Bryant Development and Review Committee Meeting

Date: April 18, 2024 - **Time:** 9:00 AM

3. The Villages at Magnolia Lane Phases 2-3 - Preliminary Plat

Hope Consulting - Requesting Recommendation for Preliminary Plat Approval

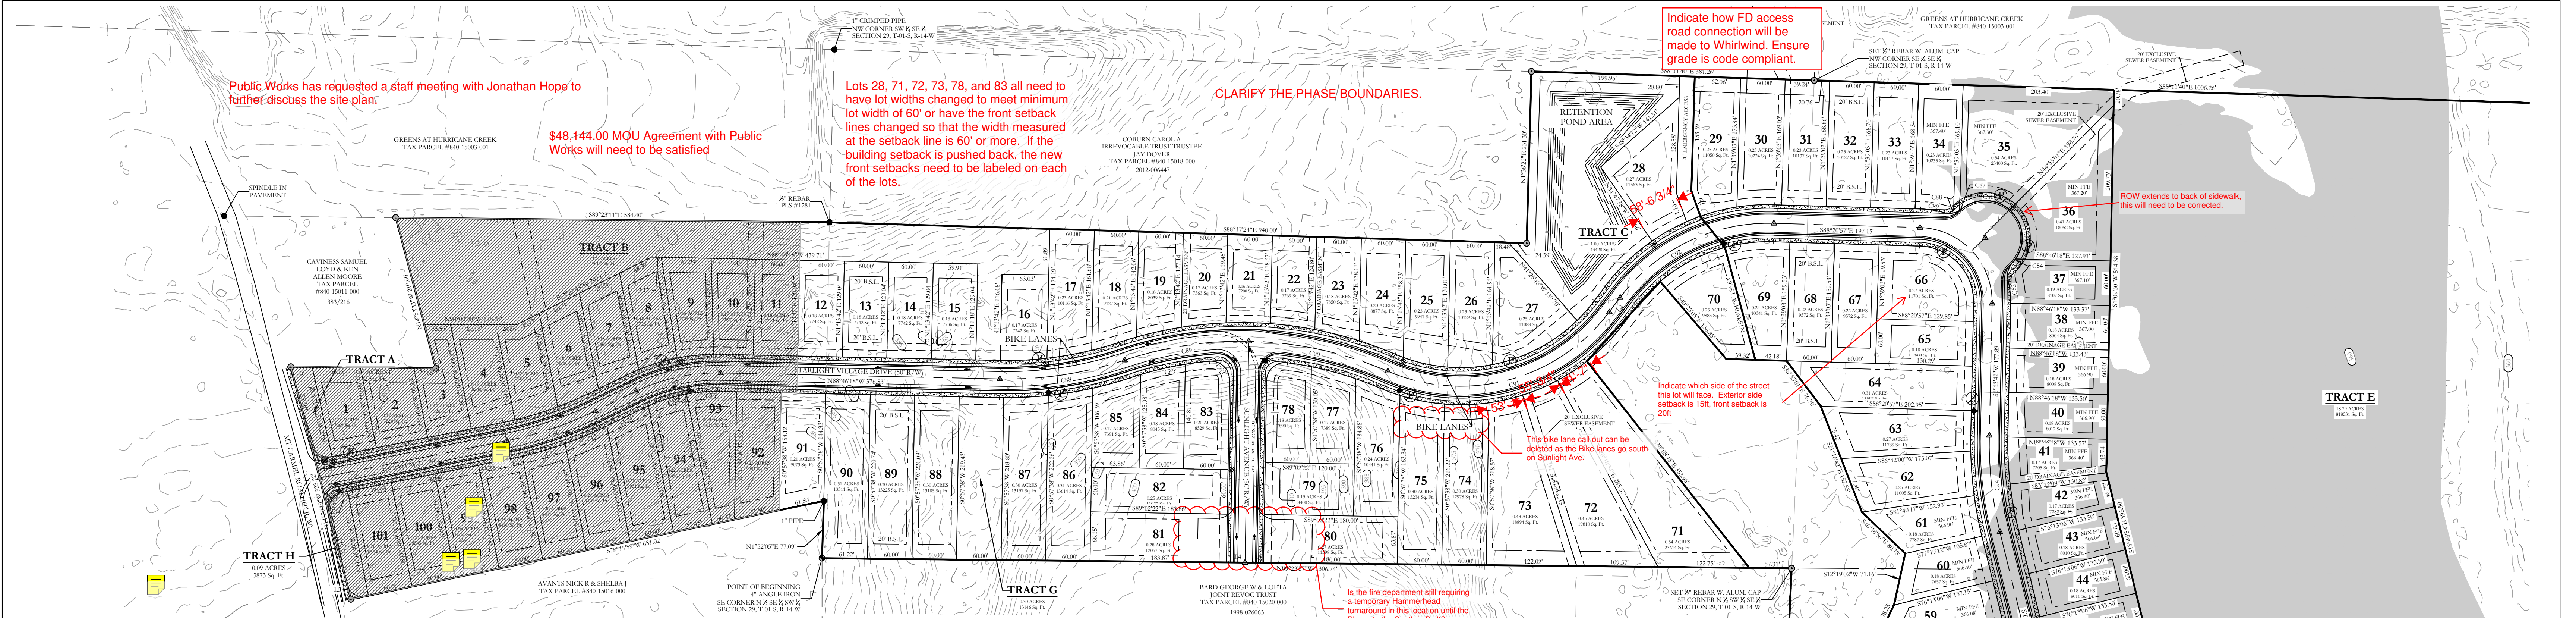
Indicate how FD access road connection will be made to Whirlwind. Ensure grade is code compliant.

ROW extends to back of sidewalk, this will need to be corrected.

DATE:	10-05-2023	C.A.D. BY:		DRAWING NUMBER:
REVISED:	11-21-2023	CHECKED BY:		19-0238
SHEET:	C-1.3	SCALE:

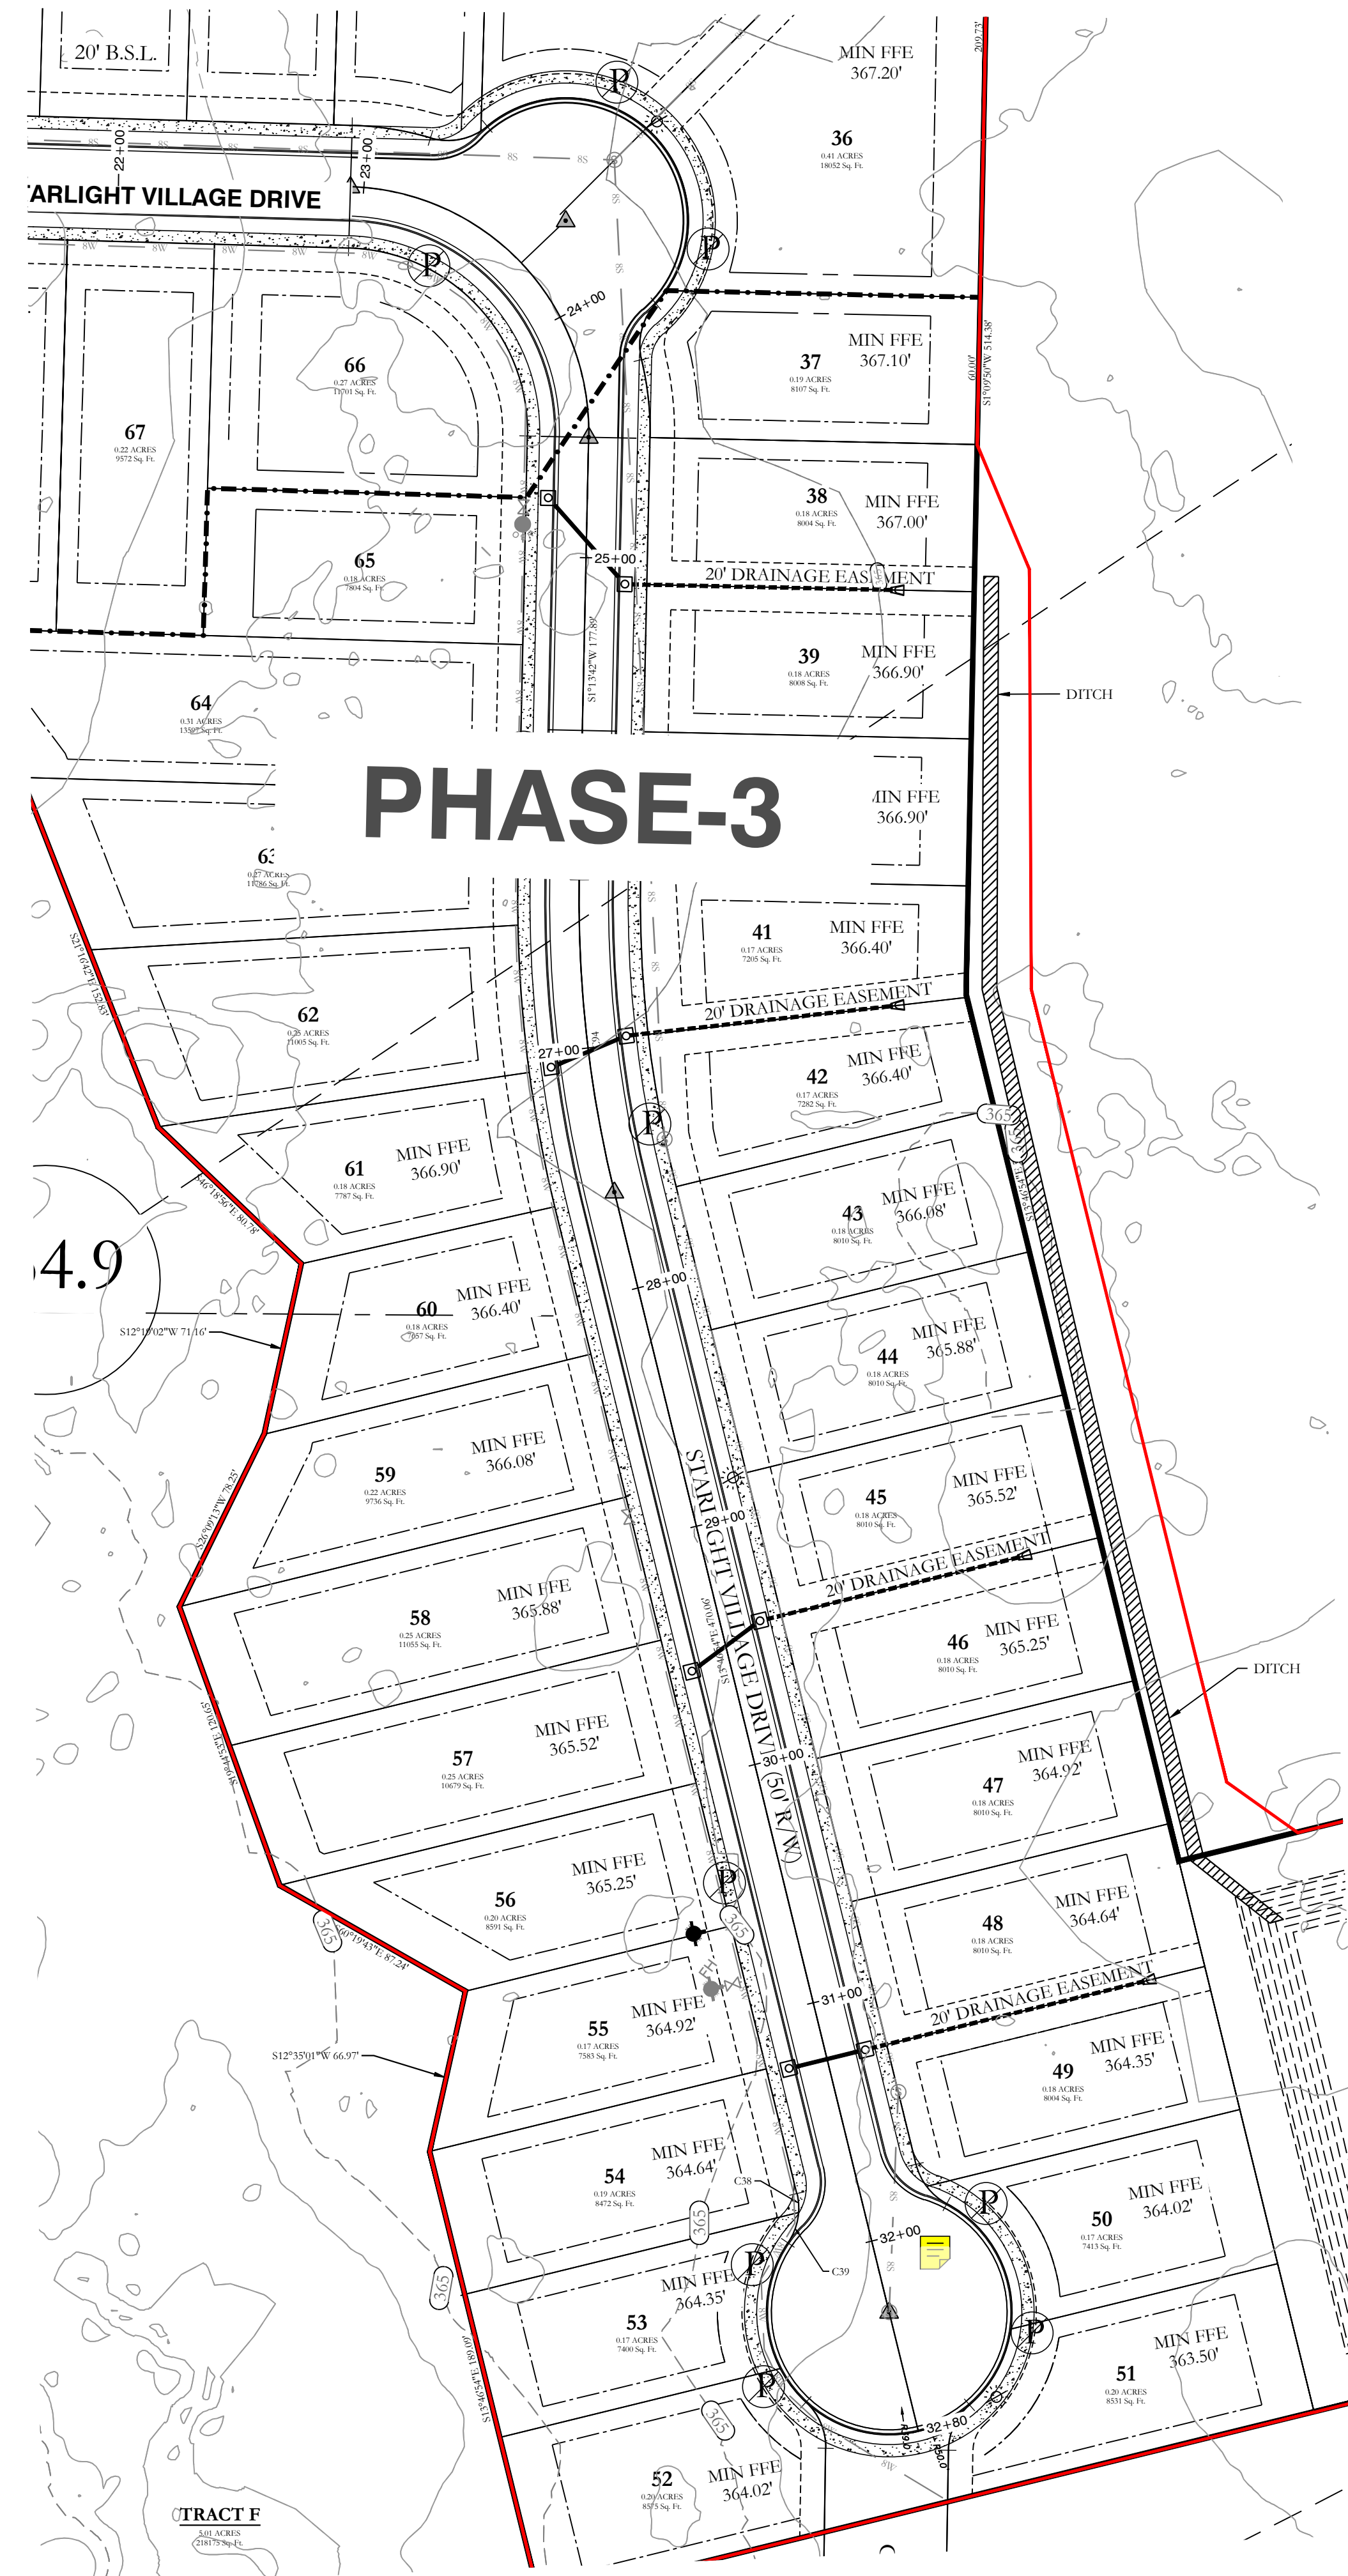
DESIGN SPEED?

WHERE IS THE CENTERLINE DATA?
SEE ALL THE NOTES ON THE FIRST TWO SHEETS
